Enclosure

Coconino National Forest (CNF) Land and Resource Management Plan Appeal Issues Affirmed Without Instruction

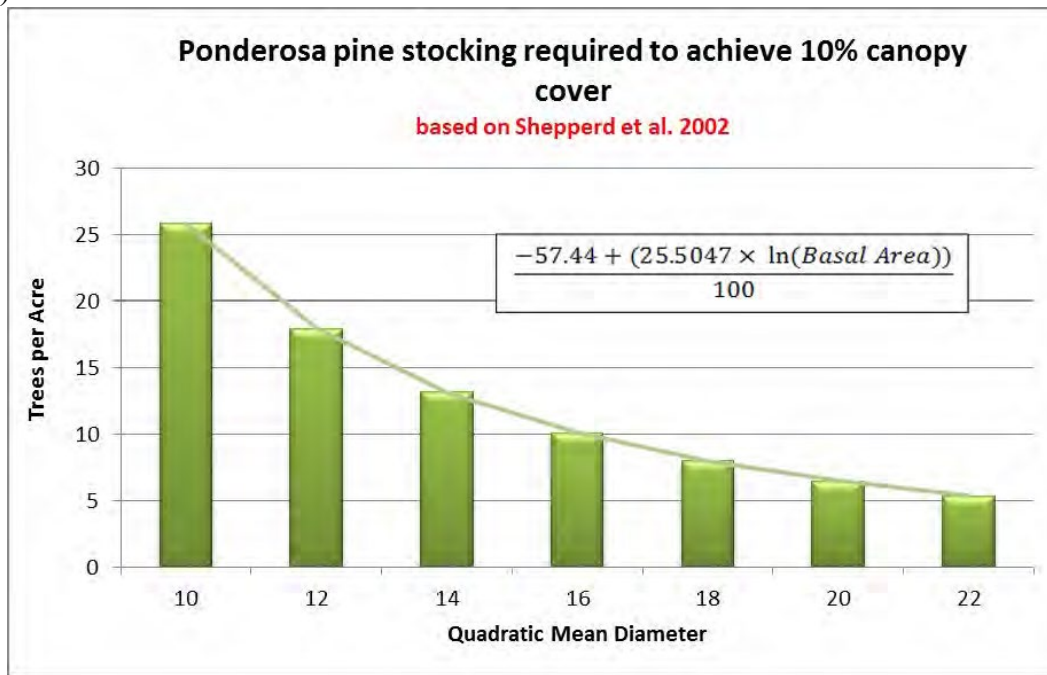
- Appellants contend the revised LRMP does not clarify the scientific determination of openness, only explains the density of forest areas are determined by basal area. It is important to clarify how openness is to be measured and interpreted.

Appellants request Desired Conditions for Ponderosa Pine and other Ecological Response Units (ERUs) be amended by inserting specific metrics to use when determining the amount of openness or amount of coverage.

The revised LRMP (Glossary, pp. 229-230) defines “openness” as, “The estimated inverse of forest canopy cover for a given area. For example, a forest with 70 percent canopy cover would have openness of 30 percent.” Openness is further explained through the definitions of openings (revised LRMP, p. 229), which discusses the relationship between basal area and canopy cover. In the definition for “openings” a description of various methods for calculating canopy cover is

included, “forest land currently having less than 10 percent canopy cover (any appropriate method, such as algorithmic relationship, growth simulators, remote sensing, or direct measurement, may be used to determine existing canopy cover [for example figure 5, shown below])”
